BARBARA SLAUGHTER FAMILY SUBDIVISION

APPLICATION NUMBER 9 DATE March 18, 2010

REQUEST Subdivision

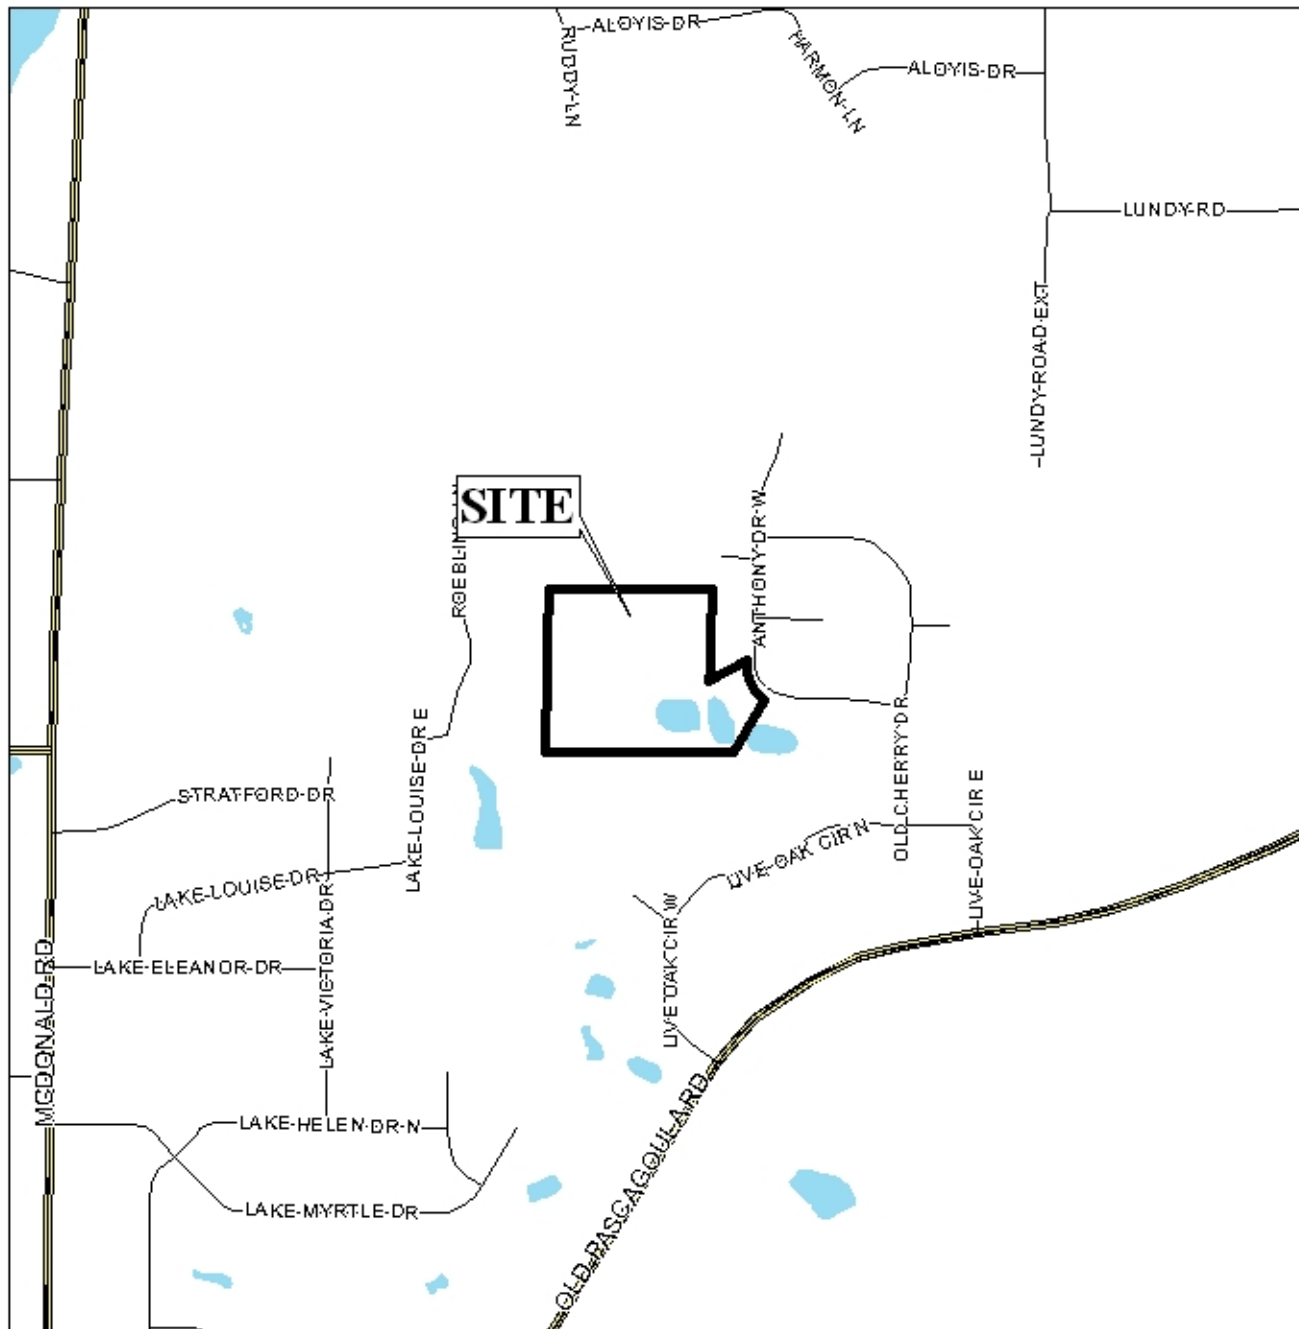
The plat illustrates the proposed 3.2± acre, 4-lot subdivision, which is located on the West side of Anthony Drive West at the West terminus of Anthony Drive South in the Planning Jurisdiction. The applicant states that the subdivision is served by public water and individual septic tanks.

The purpose of this application is to resubdivide three legal lots of record into four legal lots of record.

The site was approved as part of a four-lot subdivision in 2004, of which two of the lots were flag lots. The applicant now desires to rearrange interior lot lines and create a third flag lot for family purposes. However, the Subdivision Regulations were amended in 2008 to generally prohibit flag lot subdivisions but making exceptions for family subdivisions. But in this instance, the creation of a third flag lot becomes more out of character with the surrounding neighborhood and access management becomes more of a problem along Anthony Drive West due to the possibility of multiple curb cuts in close proximity to one another. Section V.D.1. of the Subdivision Regulations states that “multiple panhandle or flag lots shall not be allowed as an alternative to road construction.” Staff believes that a more appropriate approach would be a private street subdivision which would eliminate the flag lot configuration and require only one curb cut along Anthony Drive West.

Based on the preceding, this application is recommended for denial for the following reasons:

- 1) the proposed flag lot configuration would be more out of character with the surrounding neighborhood;
- 2) access management concerns of multiple curb cuts in close proximity along Anthony Drive West; and
- 3) the subdivision could be more appropriately configured as a private street subdivision and eliminate all flag lots.
